Drury Quarry Sutton Block – Comments Tracker

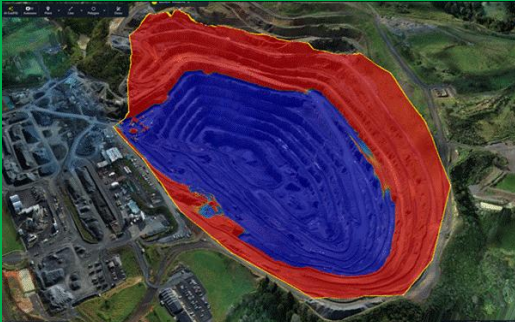
59	Andrew Rossaak (Morphum)	Freshwater and Terrestrial Ecology	<u>Wetlands</u> The assessment of potential values does not meet the assessment of values required under the NPS:F	YES	No		This response is based on the Compulsory Values set out in Appendix 1A of the NPS-FM for freshwater management units. Section 3.3 of the EclA sets out the current ecological values of the streams and wetlands. Section 5.3.2 of the EclA report sets out the stream and wetland potential value for aquatic habitats within the Sutton pit area assuming good land use practices within the current land use. The uplift in values considered include ecosystem health (Value 1 in Appendix 1A).

Human Contact (Value 2 in Appendix 1A) is considered negligible. The impacted stream and wetlands are small non-swimmable streams located within an active quarry site. They do not support, or previous had the potential to support, recreational activities (such as boating, water skiing or swimming). Threatened species (Value 3) is considered in Section 3.4 of the EclA, as part of the assessment of assessing stream and wetland habitats and values. The only At-Risk species identified was the Longfin Eel, which has been considered in the potential value assessment. Mahinga kai (Value 4) has also been taken into account in Section 3.4 of the EclA report.	
60	Andrew Rossaak (Morphum)	Freshwater and Terrestrial Ecology	<u>Wetlands</u> Wetland hydrology may be impacted for wetlands 2a south, 3 and 8 given the area of influence provided the Ground and Surface Water Report. An assessment for the potential loss of hydrology on these wetlands and adaptive monitoring is expected.	YES	No		The proposed dewatering is not expected to cause adverse effects on the hydrology of wetlands (refer to Section 3.3 and 4.7 and Figures 6 and 7 of Groundwater and Surface Water Report (Technical Report L). This is because the wetlands are sustained by shallow and perched groundwater systems that are hydrogeologically separate from the deep, regional greywacke aquifer proposed to be dewatered. The zone of influence relates only to the regional groundwater table in the greywacke. Potential effects on the shallow or perched groundwater are predicted to be limited to areas immediately adjacent to the pit, where shallow groundwater may be locally intercepted by quarry cuts along the footprint. Wetlands 3 and 8 are set back from the quarry footprint, therefore, no effects on these wetlands shallow groundwater systems are anticipated. Wetland 2a adjoins the southern extent of the wetland, and it's possible the pit excavation will intercept the shallow groundwater system. To mitigate the effects on Wetland 2a hydrology, an augmentation programme is proposed for Stream 4 and Wetland 2a (refer to Sections 9.9.3 and 9.97 of the AEE Report). In addition, ongoing assessment and monitoring of the hydraulic conductivity between wetland 2a and the upper portions of the pit slopes is proposed and required under consent Condition 30(d). This will inform setback adjustments or

groundwater barriers along the wetland's northern edge to mitigate dewatering of this wetland (refer to Section 9.3.2 of AEE report). In addition, shallow groundwater within and outside the quarry catchments will be monitored using 10 shallow piezometers (as outlined in Proposed Conditions Appendix 1: Schedule A Groundwater Monitoring Bores and Trigger Levels) to identify and mitigate any potential adverse effects on shallow groundwater and associated wetlands.	
61	Andrew Rossaak (Morphum)	Freshwater and Terrestrial Ecology	<u>Offsets</u> There is uncertainty that the offsets are possible and meet additionality. Request evidence that the proposed offset sites are consistent with the additionality concept (eg. Letter from te Waikato River Authority and Hingaia Island has capacity as there are already numerous offsets consented at this location).	YES	No		Refer to Table 3, REAR-TE (Technical Report C) confirms no other parties have planned or committed to the proposed revegetation or enhancement actions at either offset sites: 1. Tuakau Site: Owned by Stevenson Aggregates Limited (Section 2.2.1.1.3, REAR-TE), with full control over proposed works. 2. Hingaia Island: Identified through iwi consultation as a priority for full revegetation (and with consideration to existing offset commitments for which we have coordinated with DoC and iwi on). Both sites therefore meet the additionality criterion, with documented ownership, absence of overlapping projects, and alignment with national biodiversity offsetting principles.
